PSEG NUCLEAR L.L.C.
SALEM/OPERATIONS

S1.OP-AB.RHR-0002(Q) - REV. 14

LOSS OF RHR AT REDUCED INVENTORY

REVISION SUMMARY

TIME TO REACH CORE BOILING AFTER LOSS OF RHR
(BEFORE REFUELING - 40 to 100 Days)

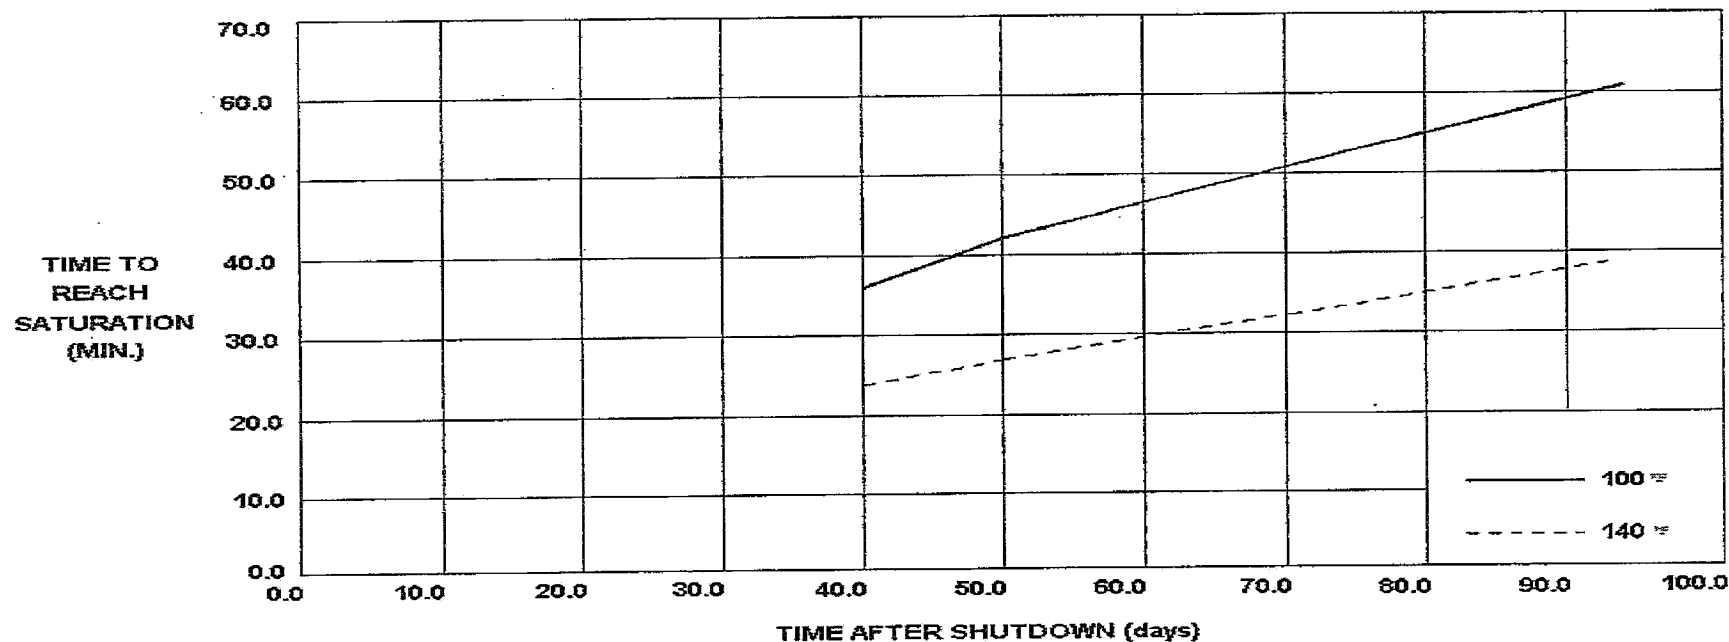
- ◆ Incorporated the following curves to provide guidance regarding RCS heatup following a loss of RHR after 40 days. This change is being incorporated in response to operator feedback, and is considered editorial in nature as these curves were previously reviewed and approved in Revision 10 of this procedure. Additionally, revised the TBD for Attachment 2 to indicate "these curves project heatup from 1 up to 1000 days after shutdown". [70056400-0010]

- Attachment 2 (Page 4 of 10) - TIME TO REACH CORE BOILING AFTER LOSS OF RHR (BEFORE REFUELING 40 TO 100 DAYS)
 - Attachment 2 (Page 5 of 10) - TIME TO REACH CORE BOILING AFTER LOSS OF RHR (BEFORE REFUELING 100 TO 1000 DAYS)

TIME TO REACH CORE BOILING AFTER LOSS OF RHR
(AFTER REFUELING - 40 to 100 Days)

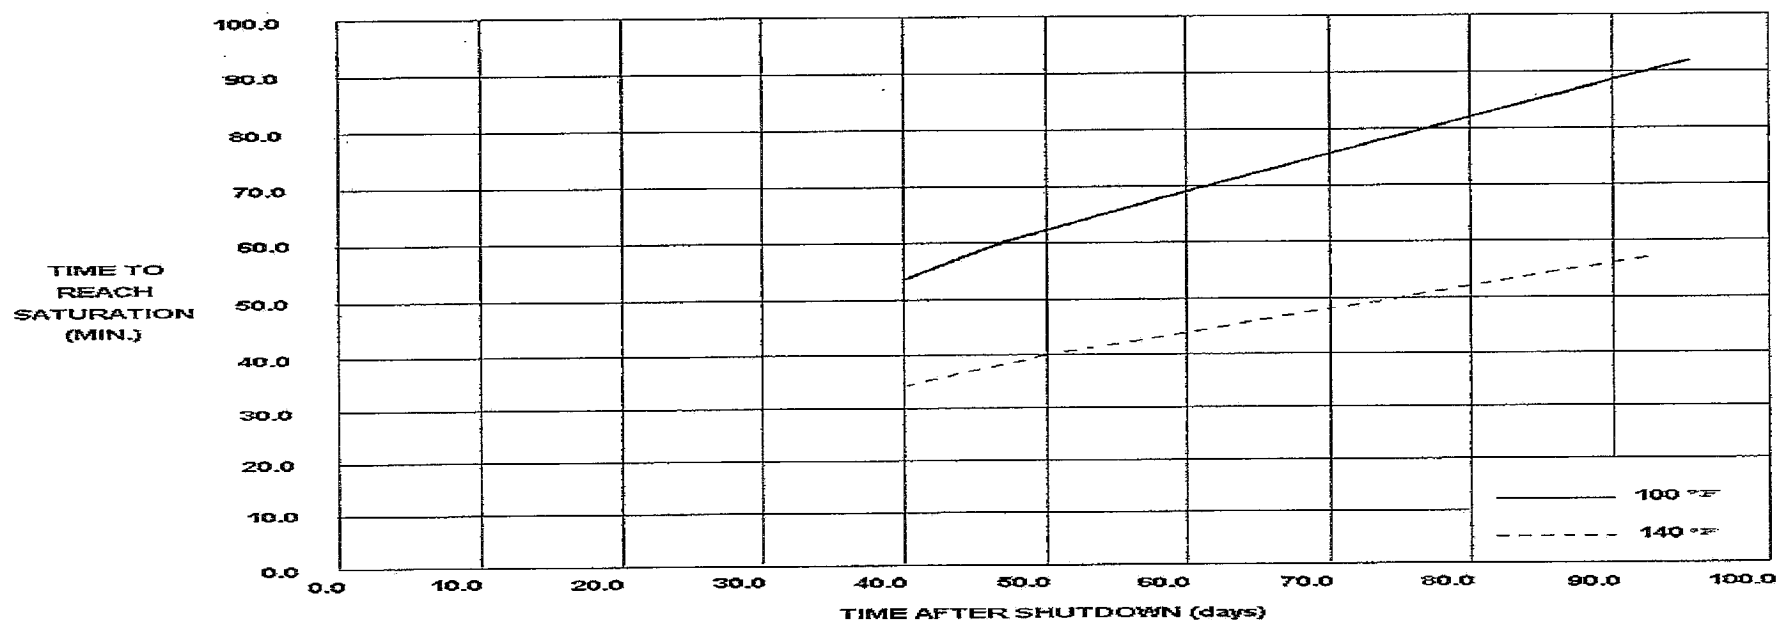
- Attachment 2 (Page 9 of 10) - TIME TO REACH CORE BOILING AFTER LOSS OF RHR (AFTER REFUELING 40 TO 100 DAYS)
 - Attachment 2 (Page 10 of 10) - TIME TO REACH CORE BOILING AFTER LOSS OF RHR (AFTER REFUELING 100 TO 1000 DAYS)
